# THE GLIDING FEDERATION OF AUSTRALIA

## AIRWORTHINESS DIRECTIVE GLIDERS/POWERED SAILPLANES

GFA/AD 222

**SUBJECT:** Wear in the horizontal tailplane locating fork to be rectified and reduced in future service.

Fig. 1.

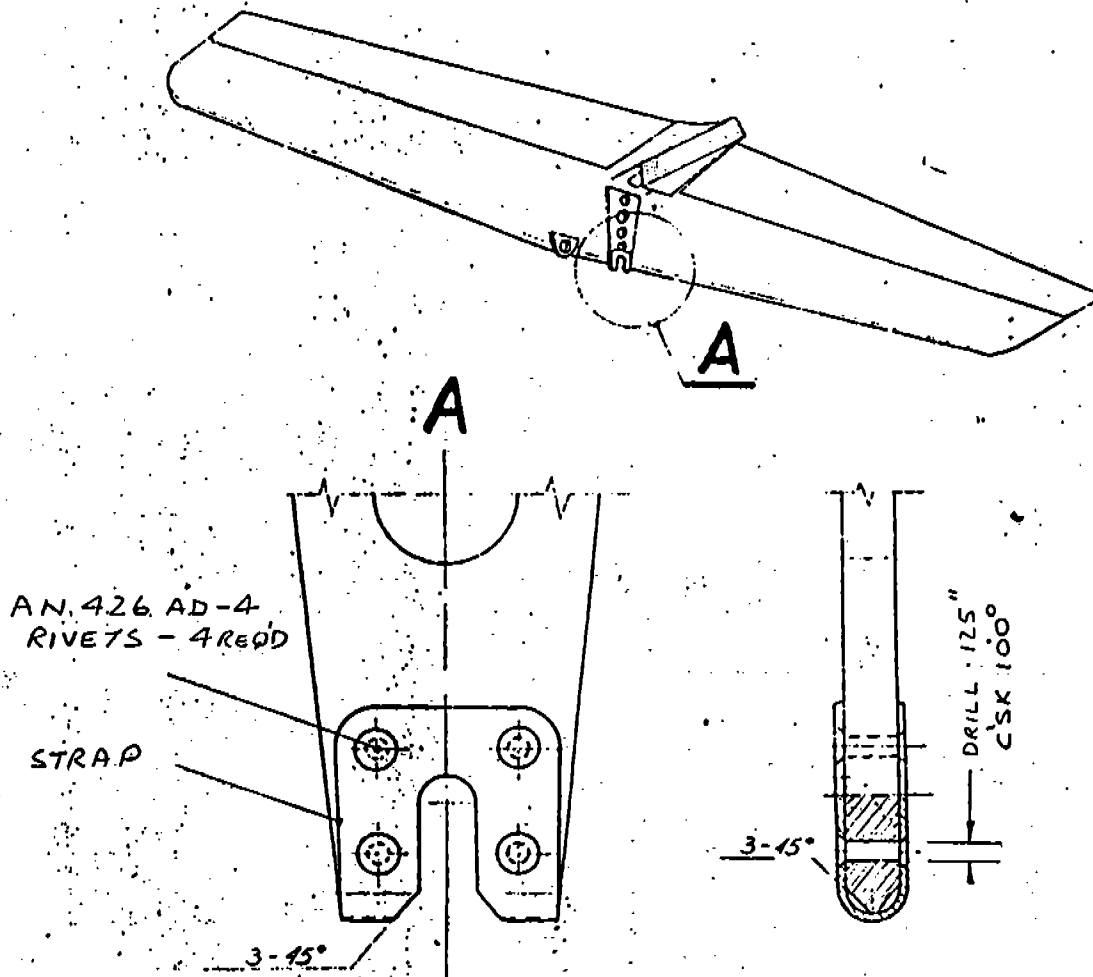
- (1) Fig. 1. details the modification fully.
- (2) If factory supplied wear straps are not available, straps manufactured to fig. 2 from 4130 Sheet steel, 1mm thick (approx) combined with AN 426 AD C'SK rivets 1/8" dia. will be acceptable, etch prime or similar is to be provided between the steel fitting and the alloy fork.
- (3) On completion the play should be within tolerance (max slop .3mm) and the tailplane angle of incidence should be as specified in Service Manual.
- (4) Modification details to be entered into log book.
